ZONING ADMINISTRATOR REGULAR MEETING AGENDA

2. SC25-0021 - 465 Benvenue Avenue - Yizhou Xu

ZONING ADMINISTRATOR AGENDA REPORT

SUBJECT: SC25-0021 – 465 Benvenue Avenue

SHEET TITLE:
**PROPOSED
ELEVATIONS**

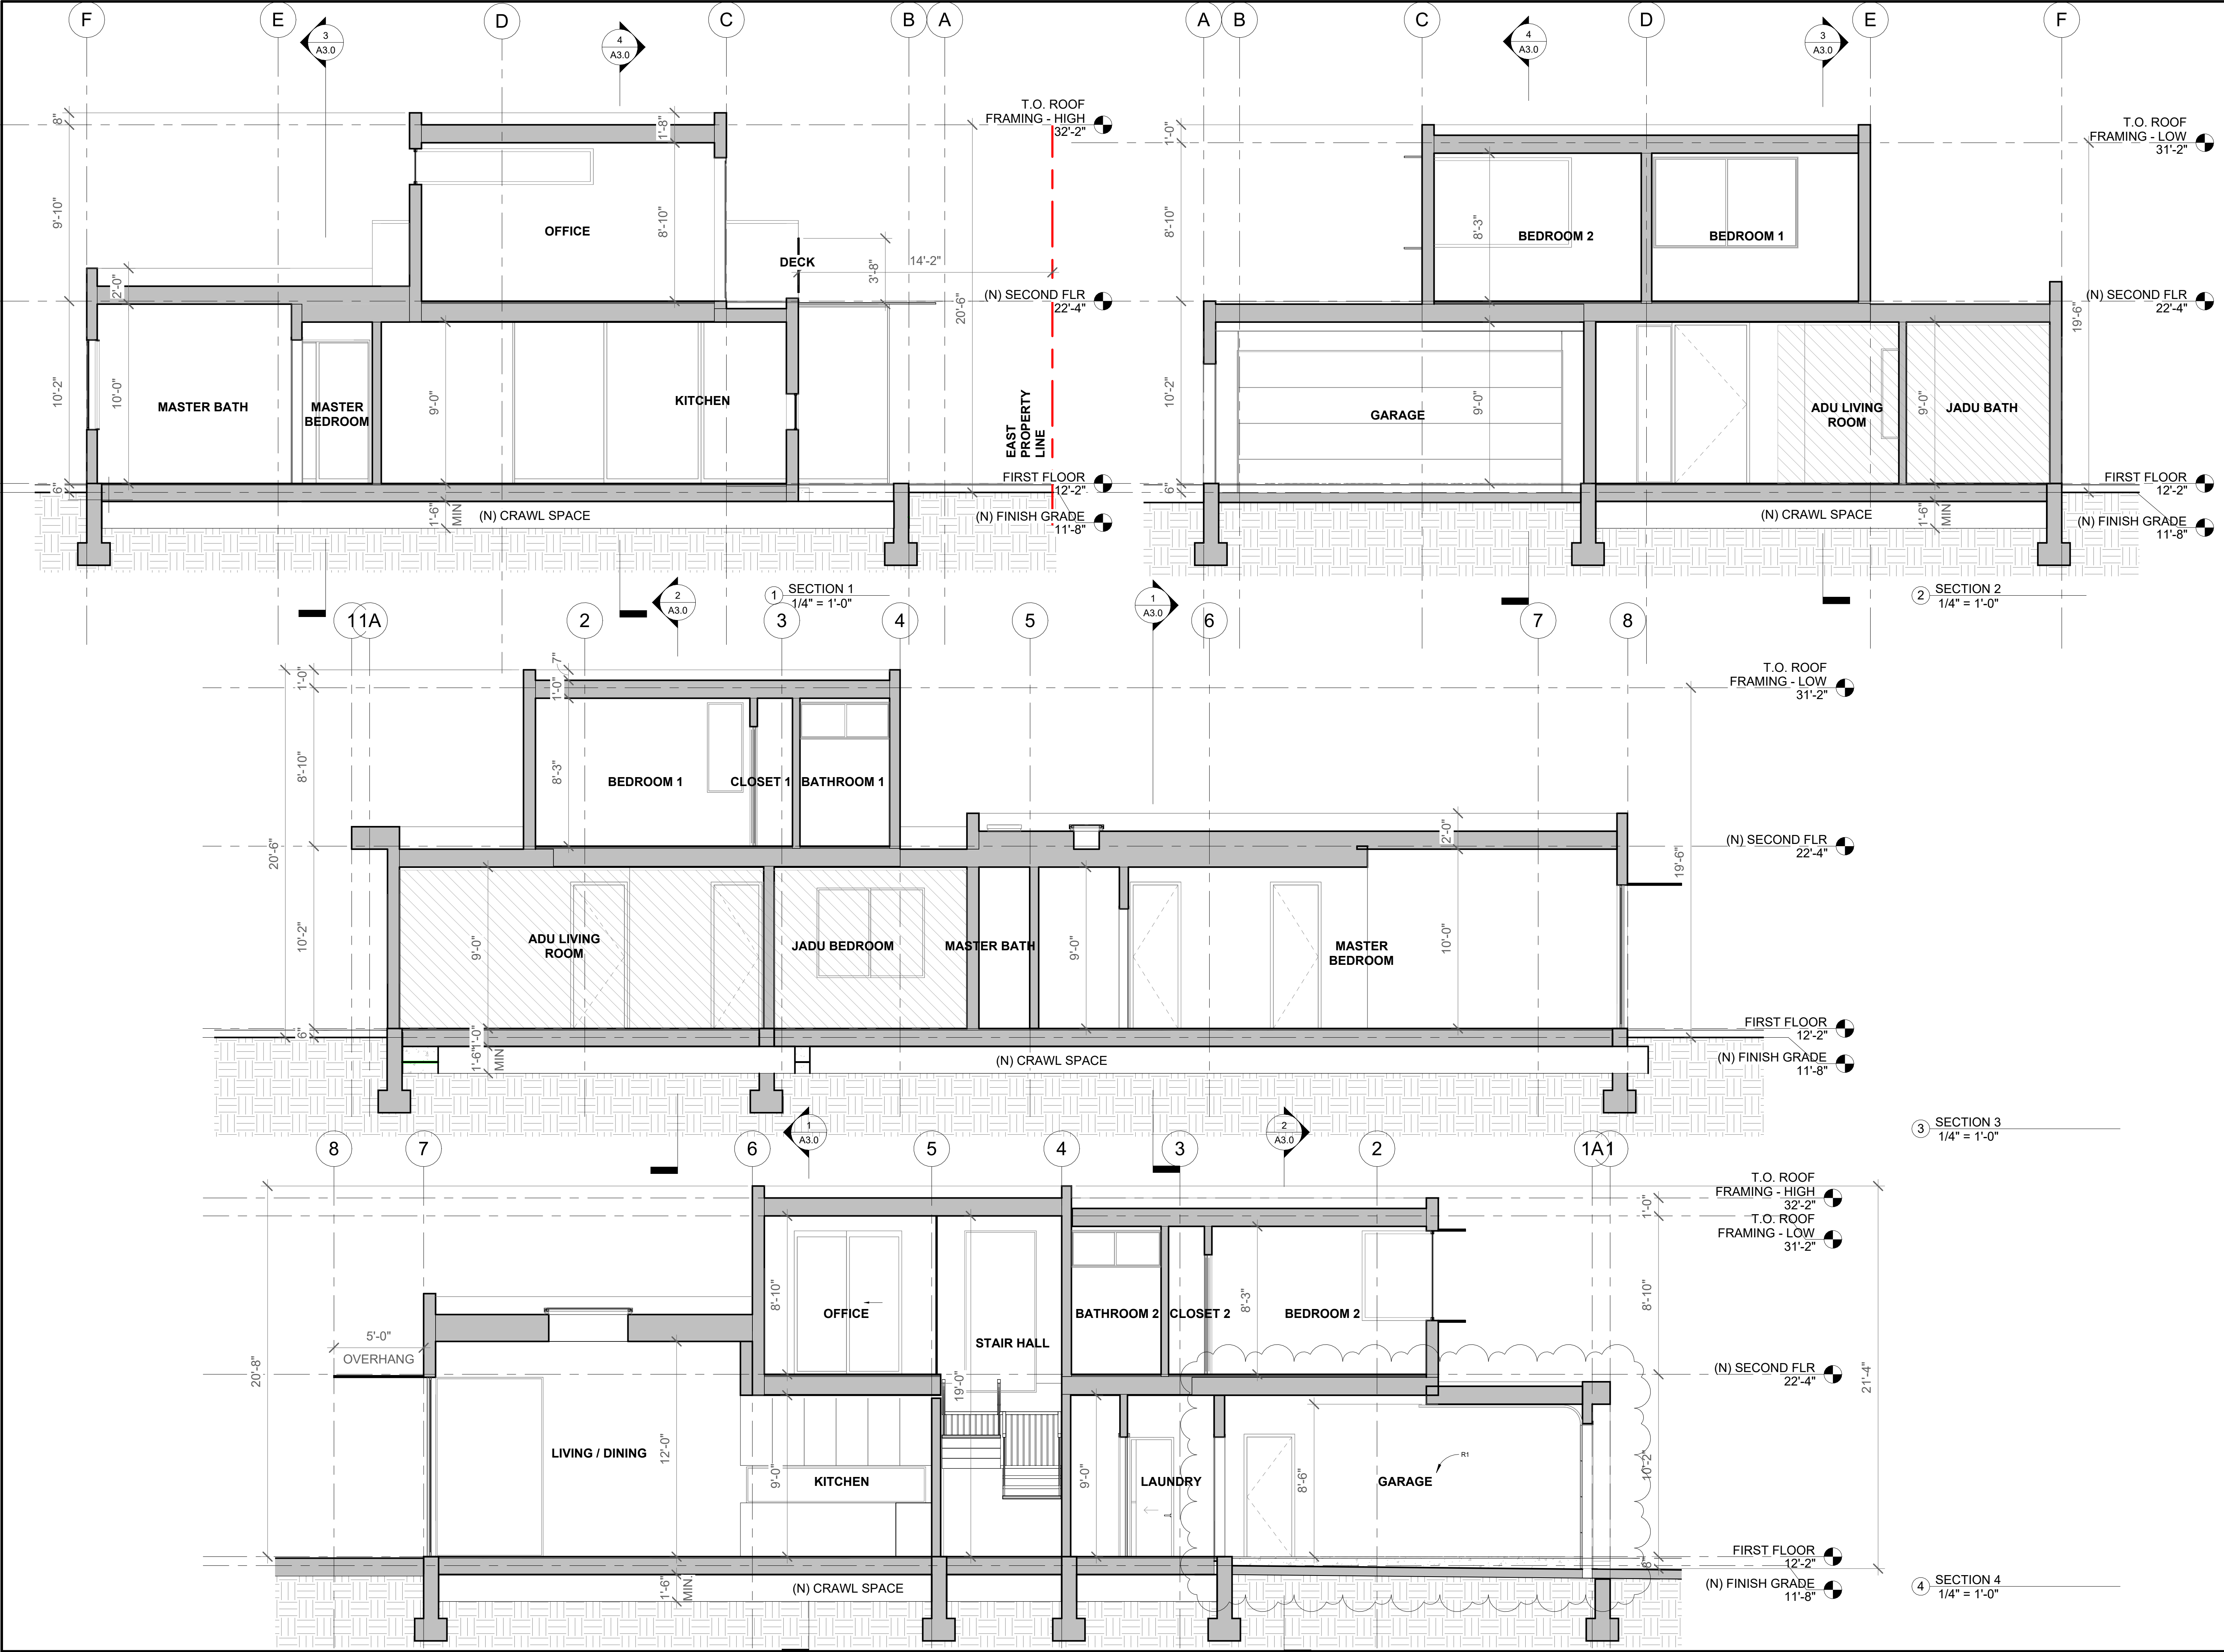
The proposed design includes two exceptionally large second-floor windows on the west side of the house, directly facing the most private areas of our home—three bedrooms and one bathroom. While the applicants state that approximately nine trees will be planted between the two properties, the plans do not specify the trees' planting height or the timeline required for them to provide effective privacy screening. Based on typical growth rates (1–5 feet at planting and approximately 2 feet per year), it takes at least five to seven years before these trees offer meaningful privacy. Given the two areas those windows are located (stairway and bedroom) have big windows on other sides, we requested either removal of these windows or conversion to clerestory windows above eye level, which will not compromise their intaking of light. These requests were not addressed in the resubmitted plans.

state. However, the placement and size of the two west-facing second-floor windows directly overlooking our private spaces represents a clear and objective privacy intrusion. I respectfully request that the City give careful consideration to these issues and support the community in preventing approval of a plan that causes such disproportionate impacts to adjacent properties.

LANDSCAPE PLAN

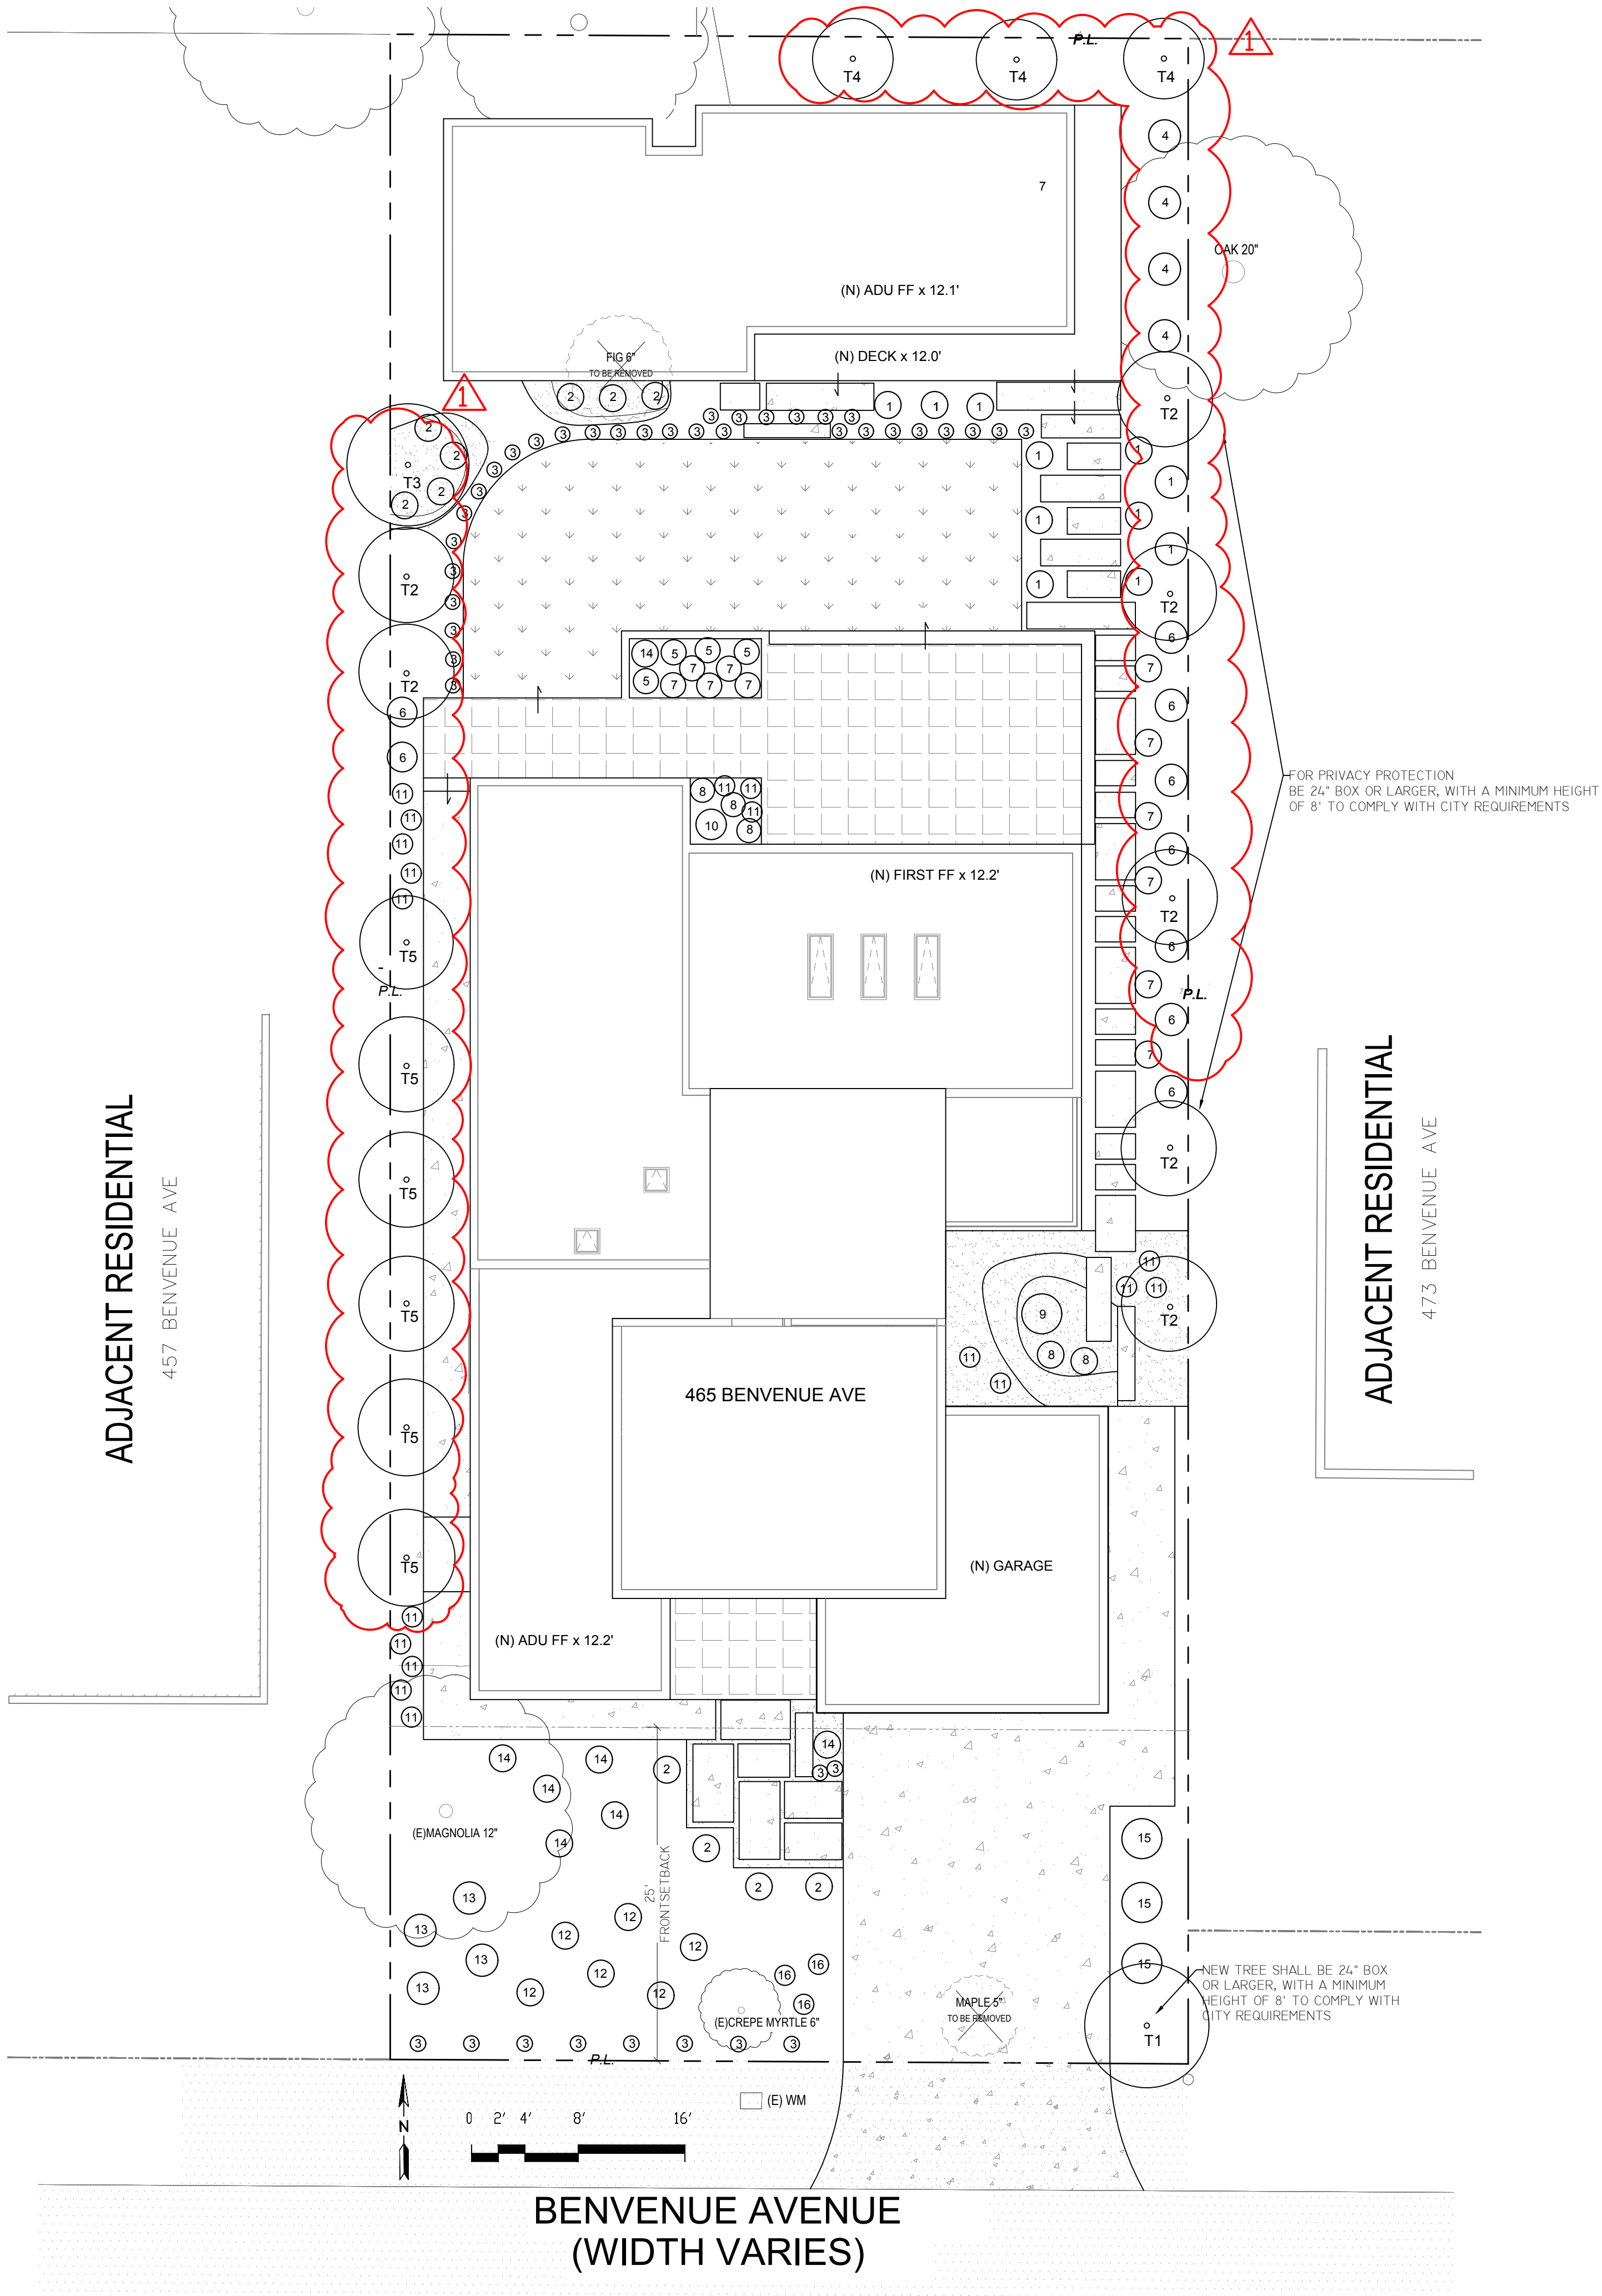
Los Altos' mature tree canopy is a critical environmental resource—contributing to cooling, water retention, air quality, and neighborhood character. Based on the plans shared with neighbors, the combined massing of the new main residence (including the square-footage expansion enabled by the JADU configuration) and the sizable detached ADU occupies nearly all viable planting areas. While a medium magnolia in the front yard is being preserved, the remainder of the landscaping plan relies on ornamental or small-scale plantings that do not replace the ecological value of a true canopy tree.

I respectfully request that the Planning Department evaluate whether the current site layout provides adequate space for present and future large-canopy trees, and whether adjustments to building placement or massing could better support the city's environmental and neighborhood character goals.
